Wheel Horse

Service Bulletin

13

SUBJECT: RMR 32-60 ROTARY MOWER

RH Mounting
Angle Assembly
#3191

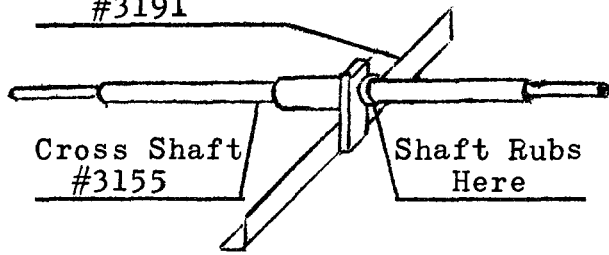
In cases of excessive belt wear of the 30" belt on the rotary mower, a check should be made to be sure that the tube, guard mount, part #3182 is not rubbing on the belt. In the event it is rubbing, a new part #3709 is available at no charge, which will rectify this problem. It should be installed as shown in the cutaway view and be adjusted by turning the bolt so that there is 1/8" clearance with the mower belt engaged (TIGHT) and the lift lever all the way back.

NOTE: The RH Mounting angle assembly, part #3191, in some cases rubs against the cross shaft, #3155, and causes friction.

A few drops of oil will usually rectify this problem, but in the event of excessive friction, part #3191 will be replaced under warranty.

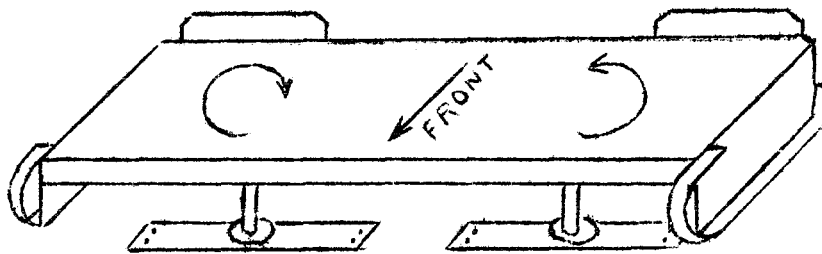
To properly install the blade tips on the rotary mower, fasten the two #3133R blade tips on the right spindle and the two #3133L blade tips on the left spindle.

NOTE: Reversed blade tips will leave center strip uncut and will leave cut grass with torn look.
